**CITY OF SEATTLE
ANALYSIS AND DECISION OF THE DIRECTOR
OF THE DEPARTMENT OF PLANNING AND DEVELOPMENT**

Application Number: 2205140

Applicant Name: Tim Hamann and Dennis Boone,
Anderson & Boone Architects, for University Mazda

Address of Proposal: 4546 Roosevelt Wy NE

Figure 4. Perspectives of the proposed structure, from northwest and southwest, respectively.

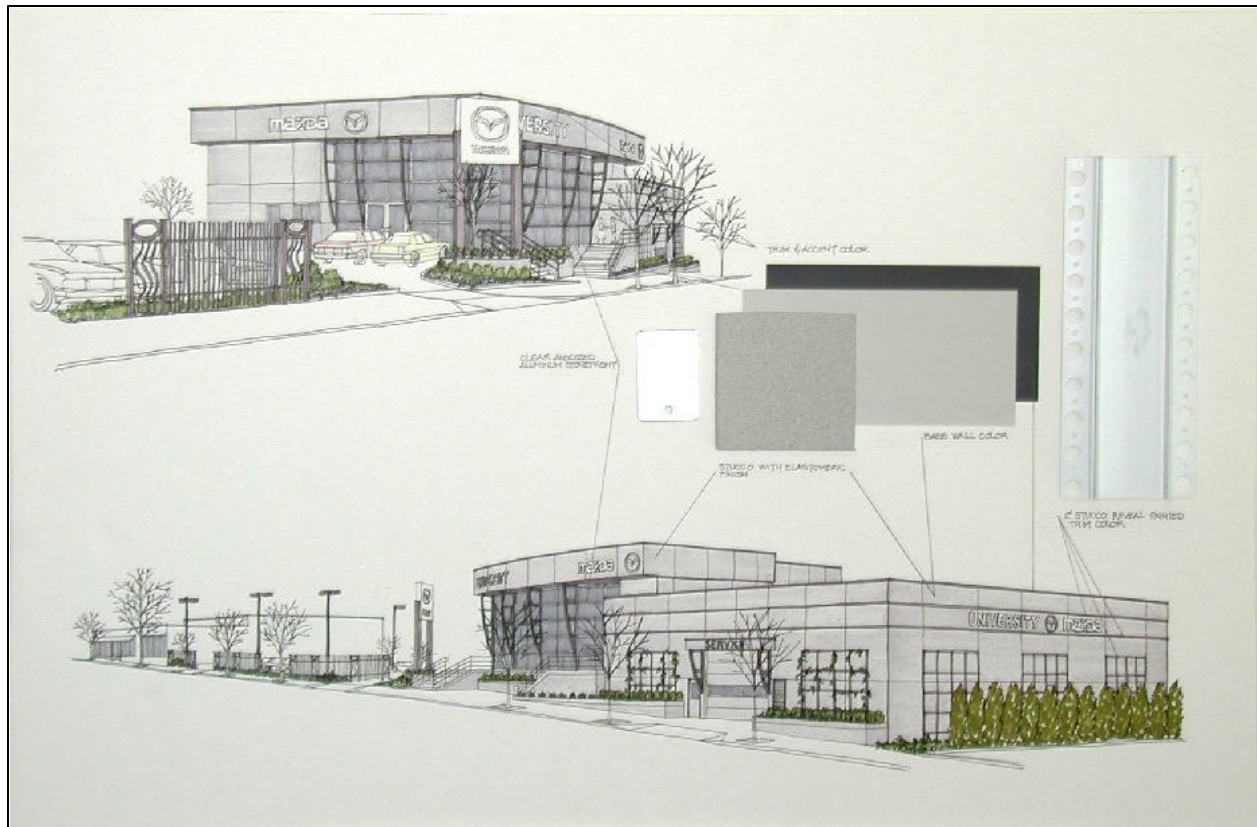
Proposed finish materials consist of a stucco base painted with a synthetic acrylic type finish, relieved by 2" interstitial reveals (see Figure 4). The more prominent retail-oriented portion of the design includes a substantial sculpted roof, visually supported by curved braces that articulate the storefront window system below. Site lighting will be shielded and focused in order to minimize glare and light spillage. The applicant proposes to reuse the internally lit pole sign currently located on the corner of Roosevelt Wy and NE 47th St, noting that the sign is subject to Mazda corporate requirements. Proposed wall signage will consist of individual letters, also internally lit. The applicant's design response is discussed further below.

Board discussion focused extensively on the quality, materials, lighting and location of the proposed sign. In general, U-District specific guidelines discourage back-lit, pole mounted signs and signs that are

- It should be lower, like a monument sign, and ideally framed by proposed landscaping.
- It should be located so as not to interfere with the building's principal façade and entry.
- It should be externally lit, or largely opaque, to communicate solidity.
- Wall signage should involve individual lettering.

The Board deliberated about the south-facing wall at some length, but reached no consensus in a specific recommendation. DPD considers the proposed score lines, wall signage, and patterned reveals to meet the original guidance.

"The design of the building uses durable quality materials including glass, aluminum, concrete, steel, and stucco. The design incorporates a curved sculptural glass and stucco surface with tall curved steel lattice braces supporting the roof. The design consists of two offset forms of different heights (north and south) which represent and emphasize the different internal functions.

"The design includes insets and surface modulations, score lines, and reveals, as well as a couple of types of lattice elements to promote visual interest.

Based on plans shown at the meeting on March 1, 2004, DPD considers the proposed score lines, wall signage, and patterned reveals to meet the original guidance related to treatment of the proposed south wall.
